Vieux Carré Commission Architecture Committee Meeting

Tuesday, June 9, 2026

827-29 St. Philip

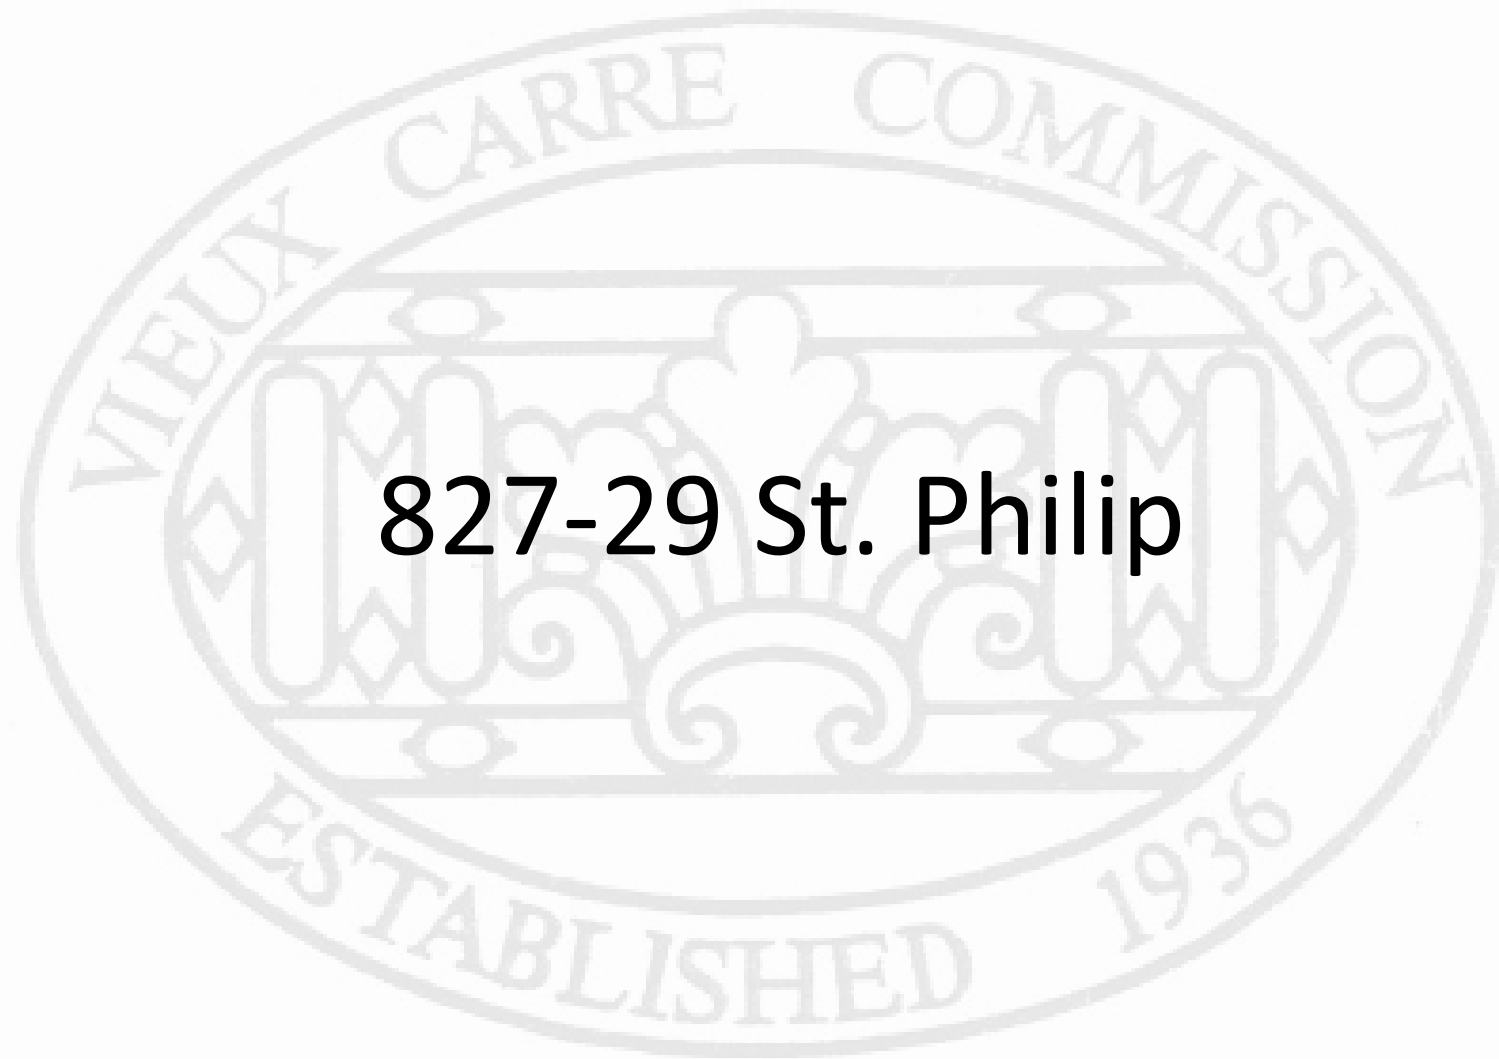
Staff issued permits for an overall renovation of the property on 04/29/2025, which included removal of a concrete slab and installation of permeable pavers in the courtyard. A central, circular fountain was to be renovated as part of this scope. The applicant is now proposing to remove the existing fountain, which is not historic, and install a new planter and water feature along the Dauphine side of the courtyard in the same footprint as an existing planter.

Submitted drawings show the fountain and planting beds set 6” off the wall with a crushed limestone bed between it and the property line fence. The fountain is a simple stuccoed water feature measuring 2’-0” tall, flanked by two smaller planters that are 2’-6” L x 40” wide. The brick planter surround is shown as 5” tall. The section drawing shows stucco applied over a concrete and rebar structure, with a rowlock course of brick on top. Staff finds the proposal to be appropriate within the Guidelines and recommends **approval**.
